ALERT SERVICE BULLETIN

212-24-170

12 December 2024

SUBJECT: MAIN DRIVE SHAFT ASSEMBLY INNER COUPLING 212-040-687-001, INSPECTION OF

Figure 1. Area where surface cracks may be found.

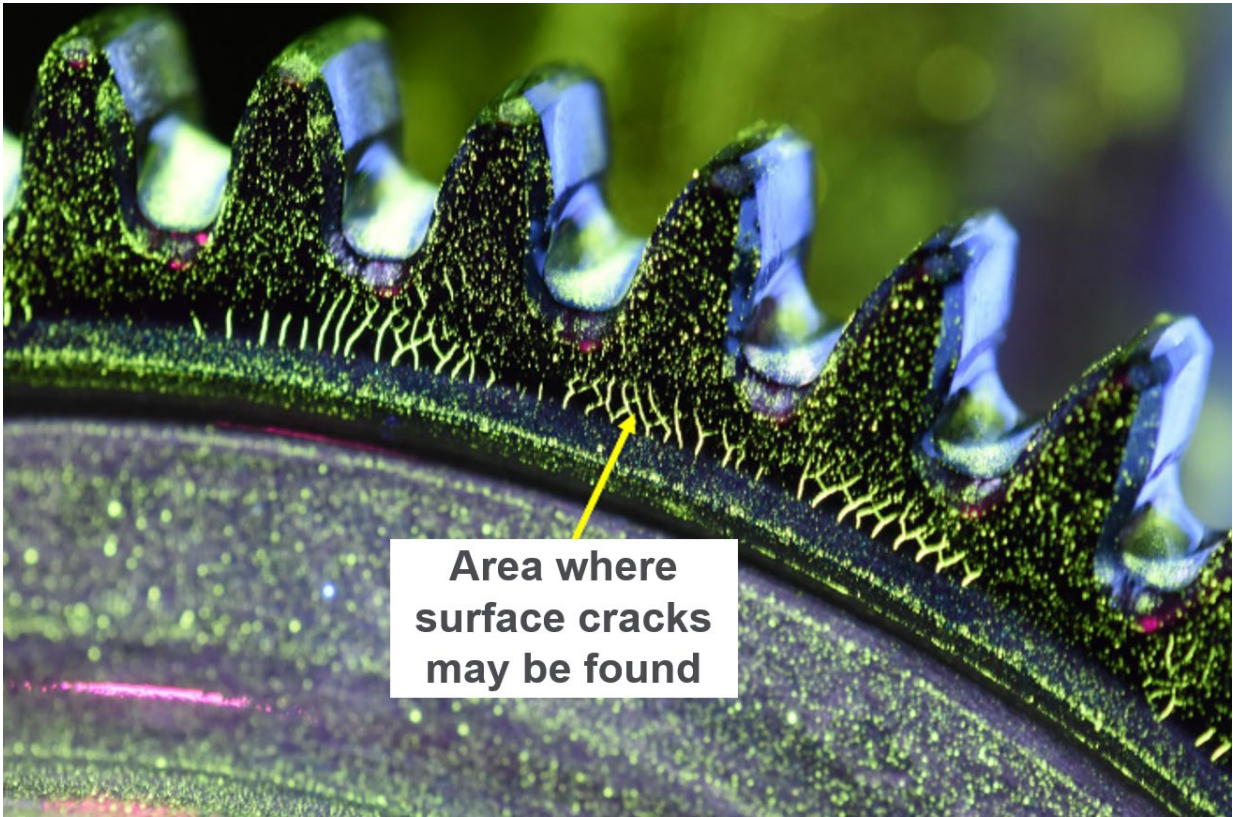
The 212-040-687-001 main drive shaft assembly inner coupling, serial number BH008845, was part of a lot of five inner couplings that may have been produced with a manufacturing defect. This defect, if present, can be detected by Magnetic Particle Inspection (MPI) as surface crack(s) at the tooth roots as shown in Figure 1 of the Accomplishment Instructions. Four of the five affected inner couplings have been retrieved and only one of the four inner couplings was found with the manufacturing defect. The suspected inner couplings were sold through spares in the 2014 timeframe.

NOTE 1: Required only if inner coupling serial number BH008845 is found with the manufacturing defect shown in the Figure 1.

1. Within the compliance timeframe listed, perform a main drive shaft inner coupling serial number verification.
 - a. If inner coupling serial number BH008845 is not installed, go to step 2.
 - b. If inner coupling serial number BH008845 is installed, perform a MPI of the inner coupling before next flight (BHT-212-CR&O, Chapter 63).
 - (1) If the manufacturing defect shown in Figure 1 is not detected, go to step 2.
 - (2) If the manufacturing defect shown in Figure 1 is detected, contact Product Support Engineering and replace the affected inner coupling before next flight.
2. Make an entry in the helicopter logbook and historical service records indicating findings and compliance with this Alert Service Bulletin.
